Model: Da-P1d	Date: 19-Mar-15	No.: RM187004
----------------------	-----------------	---------------

Subject: Firmware Release Note: NetworkDocBox		Prepared by: Y. Gaman	
From: 3rd Tech Service Sect., MFP/Printer Tech Service Dept.			
Classification:	<input type="checkbox"/> Troubleshooting <input type="checkbox"/> Mechanical <input type="checkbox"/> Paper path <input type="checkbox"/> Product Safety	<input type="checkbox"/> Part information <input type="checkbox"/> Electrical <input type="checkbox"/> Transmit/receive <input checked="" type="checkbox"/> Other (Firmware)	<input type="checkbox"/> Action required <input type="checkbox"/> Service manual revision <input type="checkbox"/> Retrofit information <input checked="" type="checkbox"/> Tier 2

Model: Da-P1d		Date: 14-May-15	No.: RM187013
Subject: Squeaking Noise from Paper Exit Area		Prepared by: J. Mochizuki	
From: Field Quality Management Department			
Classification:	<input checked="" type="checkbox"/> Troubleshooting <input type="checkbox"/> Mechanical <input type="checkbox"/> Paper path <input type="checkbox"/> Product Safety	<input type="checkbox"/> Part information <input type="checkbox"/> Electrical <input type="checkbo

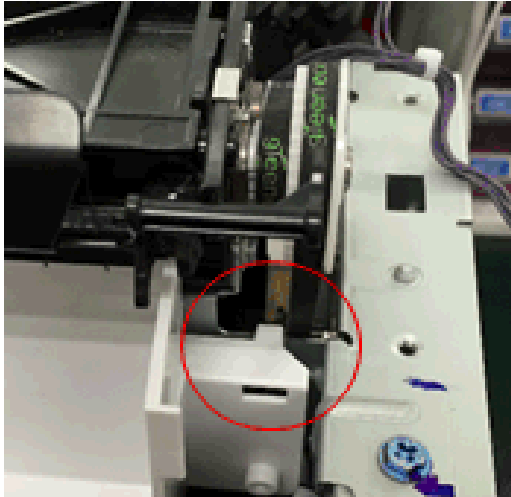
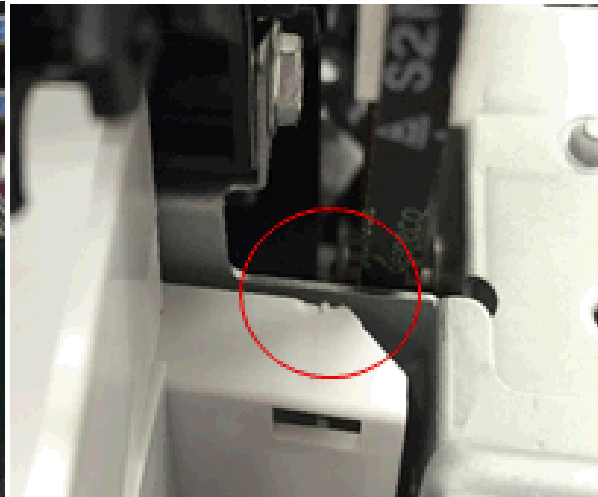
Variations in parts dimensions and assembly conditions can sometimes result in a small (or no) clearance between the fusing unit drive belt and exit cover (as shown in the photo).

The position of the claw was shifted to create enough gap between the belt and the cover.
Applied from: April 2015 production

3. Cut away the section of the claw on the cover using nippers.
Important: Be careful not to drop the shavings when you cut.

1. Remove the left and right covers (5 screws each).
2. Remove the upper cover (4 screws, 1 connector on the operation panel).

4. Reattach all parts you removed.

Note: There is no side effect of removing the claw, because it is used only for the assembly process on the production line.

m257z0004

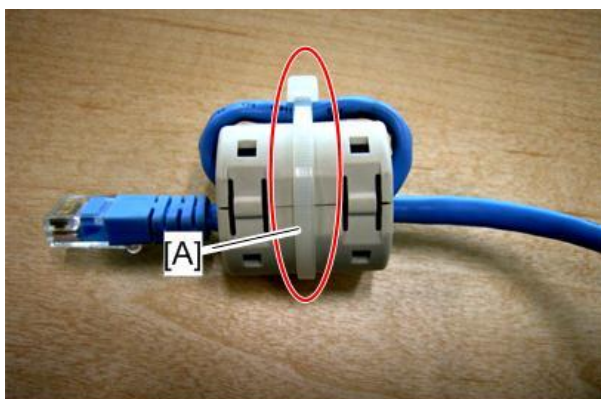
7. NA machines only: Bind both cores with the two bands [A], as shown below.

Important: These two binds are not included with options produced before March, 2015. Use the binds registered as service parts (P/N: 11050047) or similar ones.

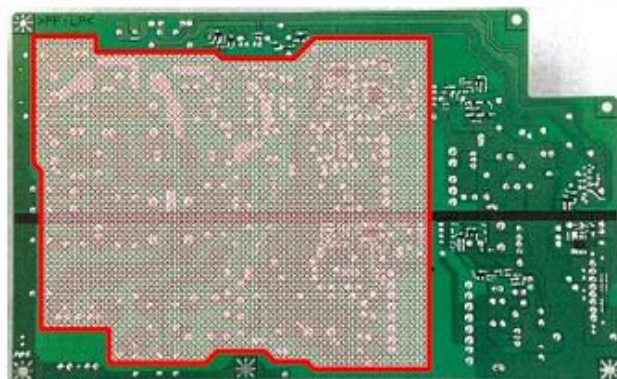
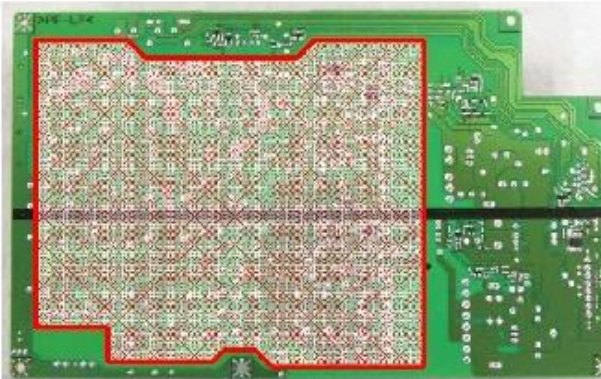
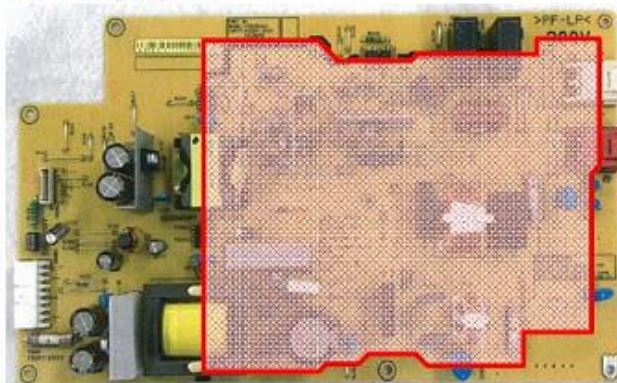
⚠ CAUTION:

NEVER touch the areas outlined in red in the photos below to prevent electric shock caused by residual charge.

Residual charge of about 100V-400V remains in the AC circuits on the PSU board for several months even when the board has been removed from the machine after turning off the machine power and unplugging the power cord.

* The areas outlined in red for M187:DOM/NA were corrected.

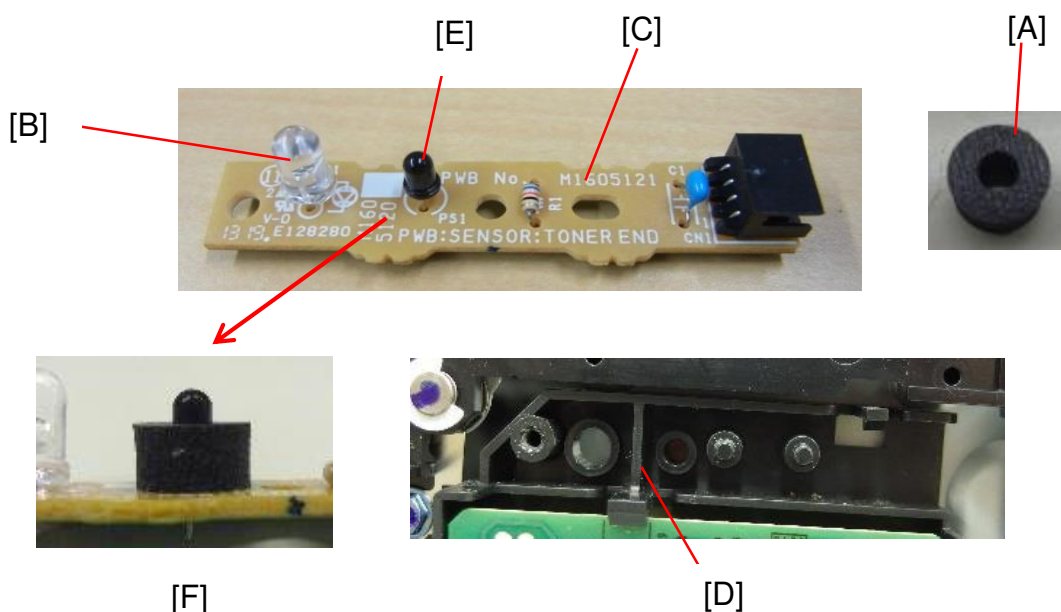
Change: The following seal [A] was added.

Reason: To further ensure SC332 is detected correctly.

Note: This SC can be mis-detected if light from the LED [B] is leaked between the toner end sensor board [C] (M1605120) and rib [D] on the sensor base (which is then picked up by the photo-detector [E]). The seal [A] will cover the lower part of the photo-detector.

IMPORTANT: Attach this seal as shown [F] if SC332 occurs in the field and the cause is not a mechanical issue with the toner transportation system.

Applied from: October 2015 production.

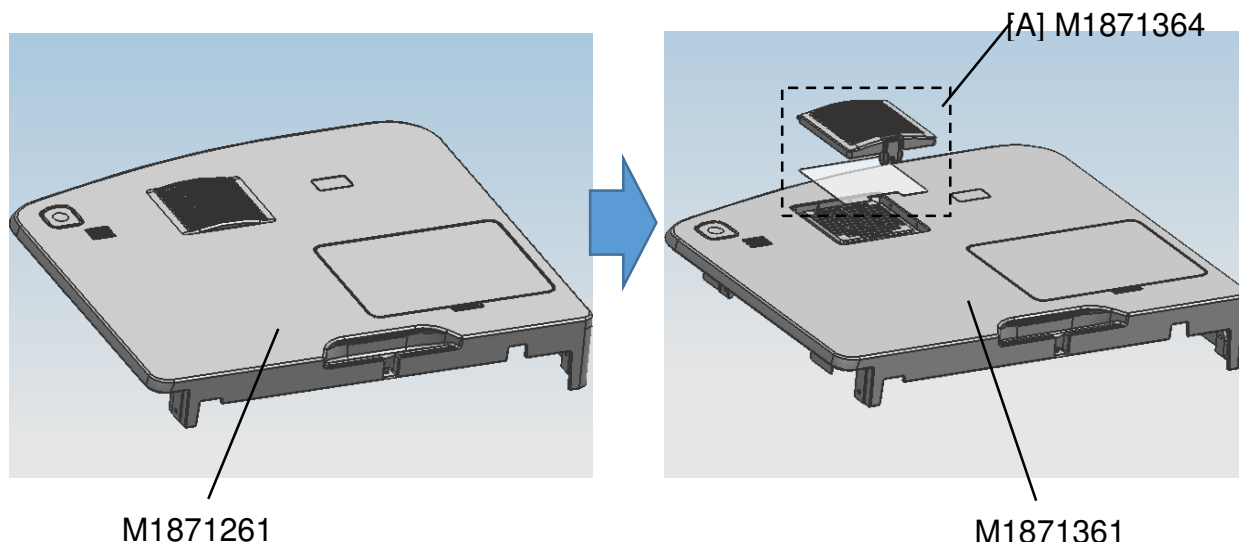
Change: The louver on the right cover was changed to a detachable air filter [A] from June 2016 production.

Reason: To prevent OPC damage caused by foreign objects entering through the air intake fan.

Note: This can cause vertical black lines on the image.

- Replace the filter periodically as part of the maintenance kit. This is because if a long duplex job is run with a clogged filter, the machine internal temperature will rise and cause toner dropping and/or image problems.
- The filter is included with the maintenance kit from June 2016 mass-production.
- When you install this filter on machines produced before June 2016, replace the right cover with the modified one (P/N M1871361).
